**PROJECT DESCRIPTION:** Demolition of commercial buildings and parking lots, and construction of 22 two-story townhome condominiums, 268 apartments in two five-story buildings, semi-subterranean parking, amenities, landscaping, and a public pedestrian paseo on a 5.4-acre site. Please see the attached project description for further detail.

We appreciated the comments we received at the Planning Commission Design Review Study Session on June 23, 2014. In response to those comments, neighbor outreach discussions, changes requested by City staff, and further refinements developed by the project design team, enclosed please find revised plans dated November 3, 2014 (Architecture) and October 10, 2014 (Landscape & Civil) for your consideration.

Re: Carolan Avenue – Rollins Road Residential Project – Revised Landscaping & Fence Design Exception

**Attn.:** **Date:** 5/21/2015  
**To:** City of Burlingame Planning Department **Project:** Carolan Avenue/Rollins Road  
Burlingame, CA  
**From:** Seidel Architects **cc:** Elaine Breeze

**A2.2**  
 Conceptual Podium / First Floor Plan  
 5/12/2014

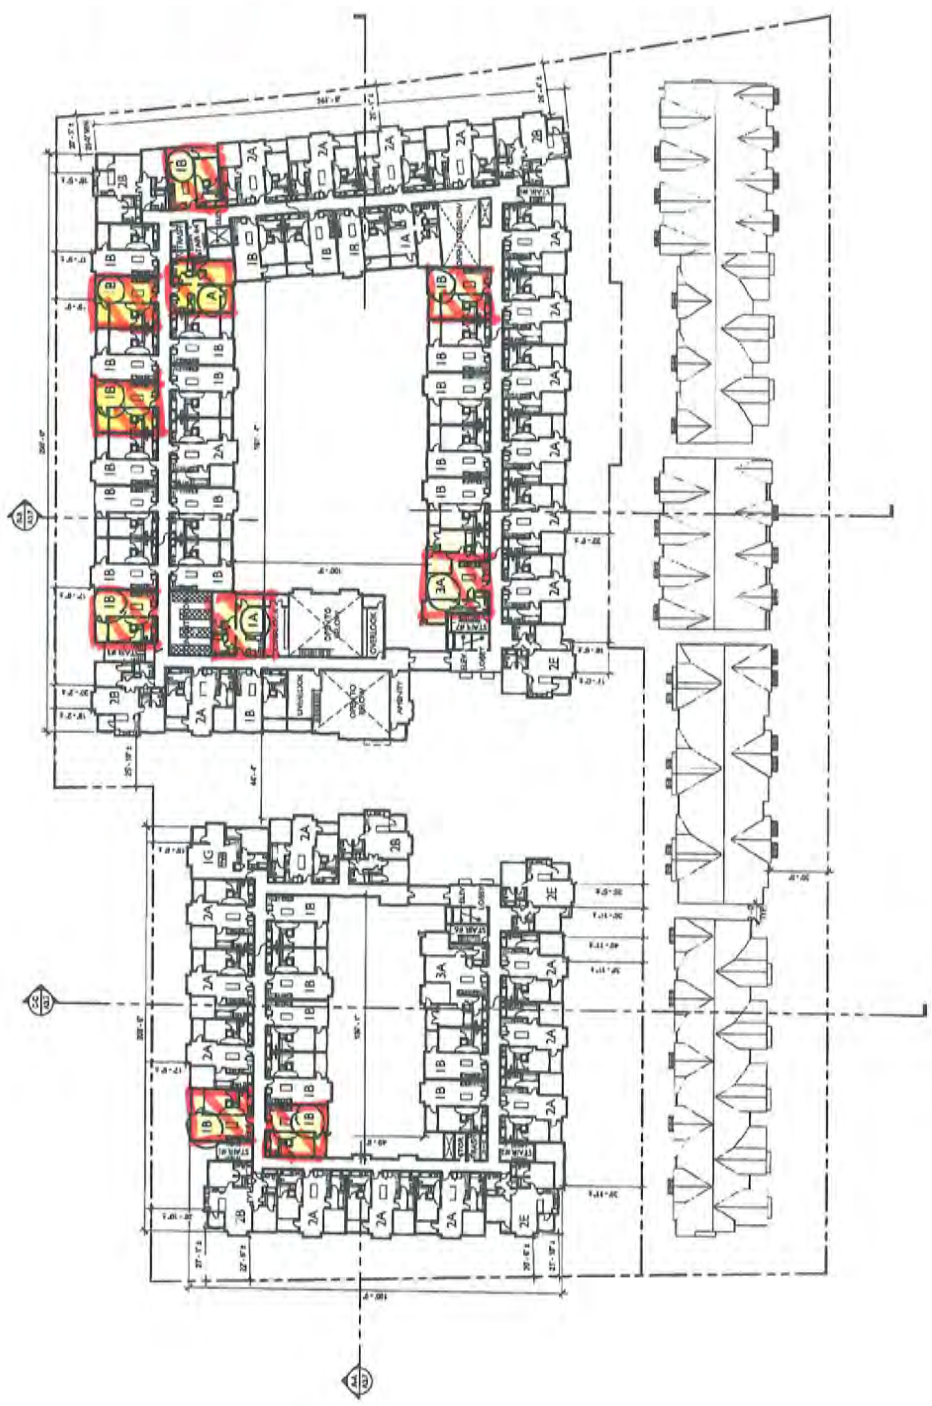
- Rendered Site Plan was modified to reflect the Podium / First Floor Plan Architecture as well as Landscape Architecture plan changes. Refer to sheet A2.2 comments for additional information.
